MARK	DATE	DESCRIPTIONS	BY	CH'D	CCO#
0	03/08/10	MEP INTEGRATION	SYC	FW	110

CONTRACT CHANGE ORDER NO._____
SHEET _____ OF _____

DETAILS
BRIDGE STRUCTURES GIRDER WESTBOUND
SKYWAY STRUCTURES - SERVICE PLATFORM #10W

E-639

CONDUIT AND GROUNDING PLAN - WB

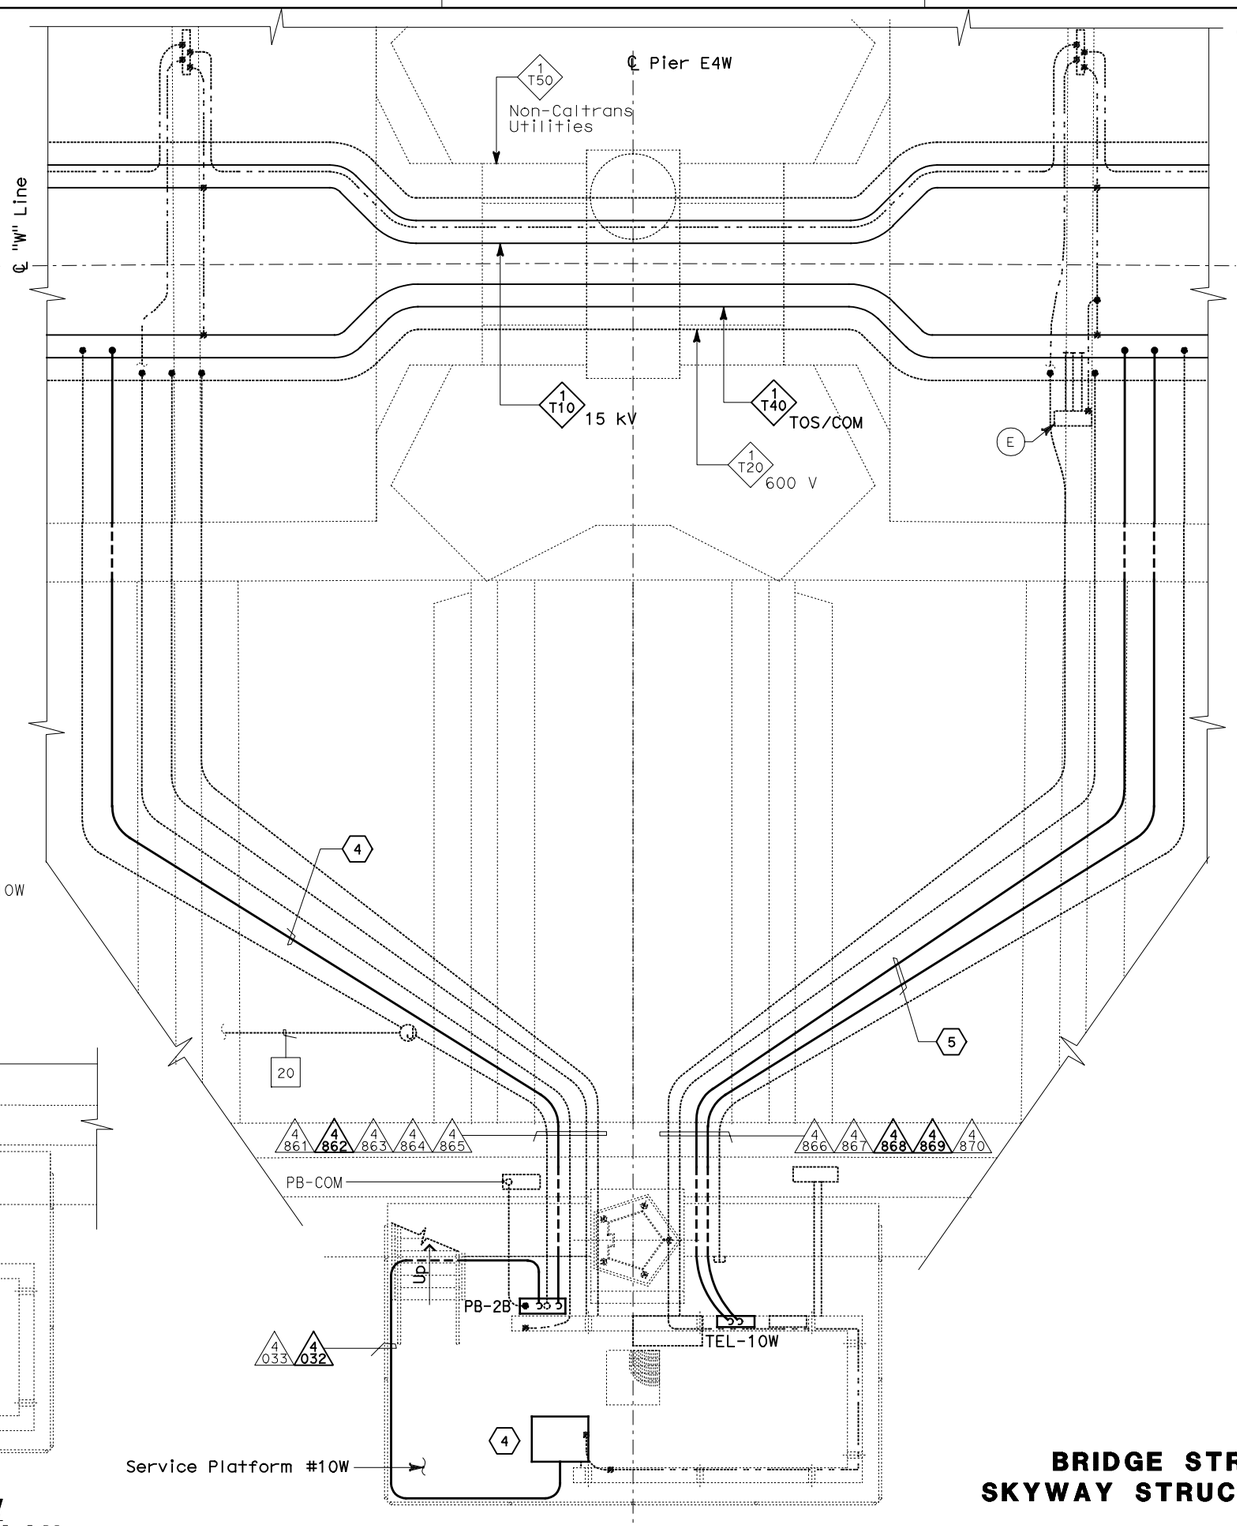
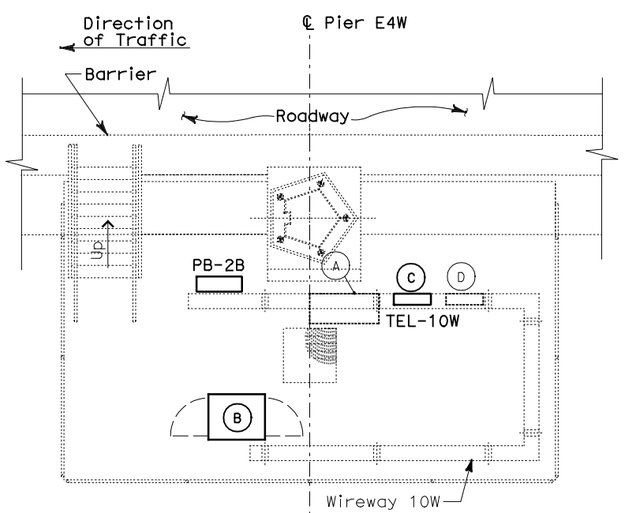
- Furnish and install the 15kV cables into existing cable tray shown on this drawing. See sheets E-664 and E-665.
   - Furnish and install the TOS fiber optic cables into existing cable tray and conduits shown on this drawing. Pull a 72 fiber in the main tray and terminate in the splice closure. See sheets E-978 through E-981.

- Inspect for system ground continuity. See sheets E-666 and E-667.
3. All cable trays, conduits and equipment shown on this drawing are existing. Bold ones are to be used for pulling cable.

(1) Furnish and install splice cable tray as shown on sheet E-663, plan detail 2.

(2) Mount splice cable tray between diaphragms and secure properly. See sheet E-663, section detail 4.

(3) Contractor shall locate the splice cable tray at Station 64+67 as shown on E-602.

(4) Furnish and install 12 fiber optic cables from Fiber Optic Splice Closure to Controller Cabinet. Route via pull box PB-2B. Coil 3m of cable inside Controller Cabinet for connections by others. The coiled end of the fiber optic cables shall be terminated with mated connectors. See sheets E-972 and E-973.

(5) Pull and terminate 50 pair telephone cable in Telephone Terminal Box. See sheets E-960, E-962 and E-964.
